To:	Sarah Hill	From:	Drainage (Barney Taylor)
------------	------------	--------------	--------------------------

Planning App Ref:	PL/2025/08543
Service Ref:	Drainage
Date:	02/02/2026

Approval of Reserved Matters (internal access, appearance, landscaping, layout and scale) following Outline Planning Permission PL/2022/09532 for 25 dwellings with access to Romsey Road, parking, open space, landscaping, and drainage and approval for pursuant to conditions 10, 20 and 22 of PL/2022/09532

Land at Romsey Road, Whiteparish, Salisbury, Wiltshire

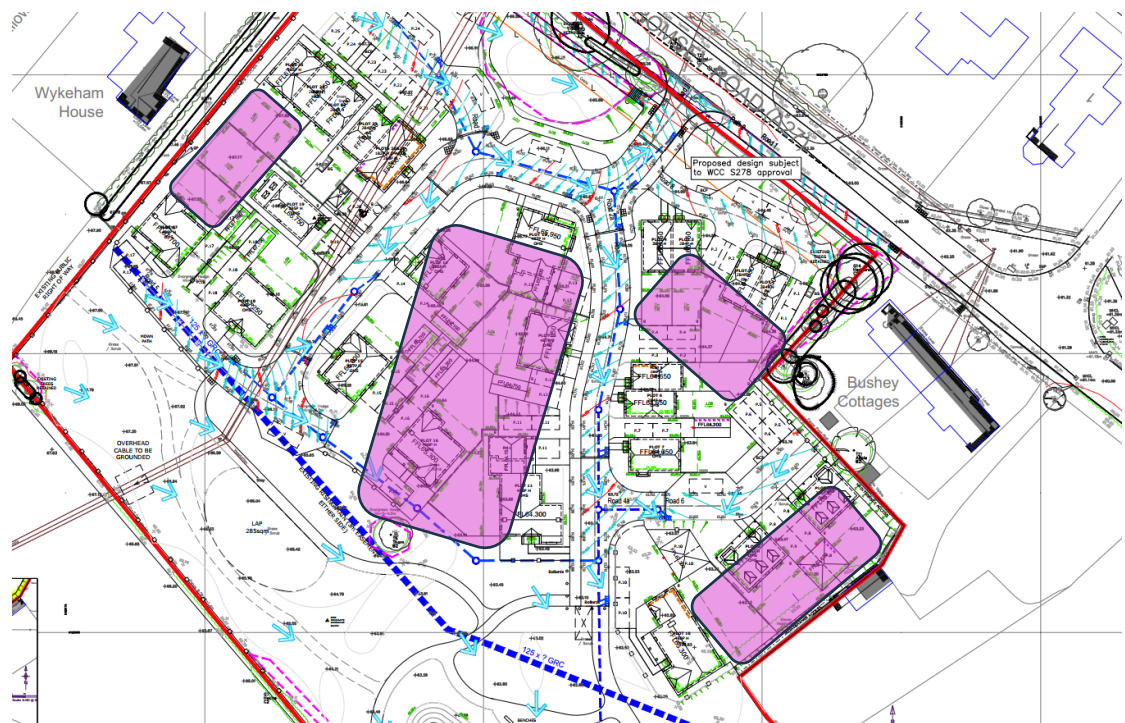
- While noting the applicant has provided a revised exceedance flow path drawing, further details are required.

Currently, it is not clear whether retaining walls will block surface water flows, or where surface water may pool. For example, it is unclear where water will pool adjacent to plots 17-21, and the exceedance arrows do not entirely match the CAD flow arrows beneath – notably by spot level 67.08 and 67.17.

The applicant must add hatching to the drawing where pooling will occur onsite during the 1 in 100+CC event, and outline whether each retaining wall will block flows, or allow flow to pass through (e.g. plot 11 & 16).

This information is required to comply with the National Standards for SuDS ([Standard 3: management of extreme rainfall and flooding](#))
